Canadian Nuclear Laboratories Near Surface Disposal Facility Project / PFP 2016-NSDF04-Csullog-CA

CEAA Reference number: 80122

NSDF – EIS Review – **Updated May 29, 2017 to include comments on CNL’s Integrated Waste Strategy**

Figure 7: Overview of the Waste Identification Program

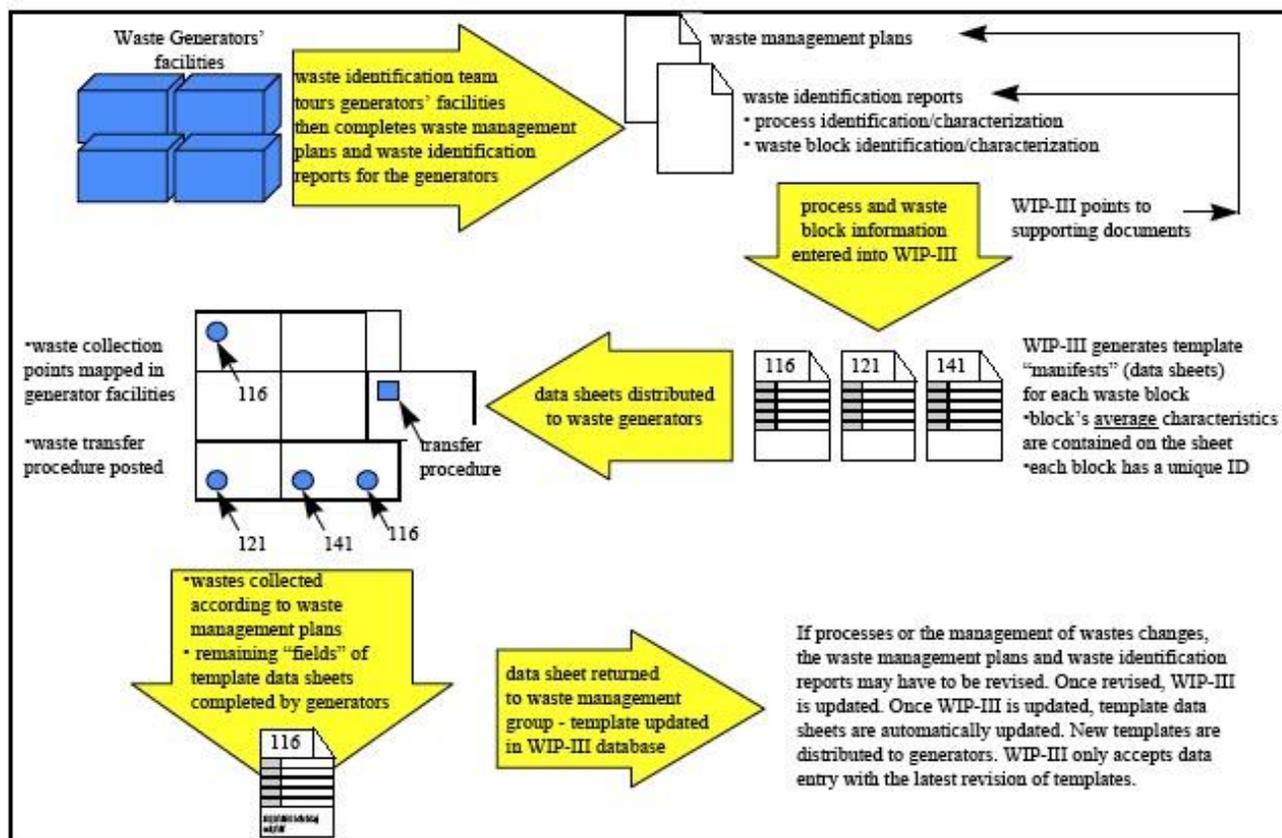
The image indicates that waste collection points for each “waste block” were identified and marked in the facilities where wastes were generated. The average characteristics of waste blocks were **estimated** (but not verified analytically) **by waste management operations staff** and pre-filled waste data sheets were provided for generators. Generators, who were given face-to-face guidance, would put their wastes at the designated collection points and, when the wastes were picked up by waste management operations, they would be accompanied by the appropriate waste data sheets. When this system “faltered”, many waste collection point signs were taken down or fell down and generator training was discontinued. In other words, front-end control of cradle to grave declined.
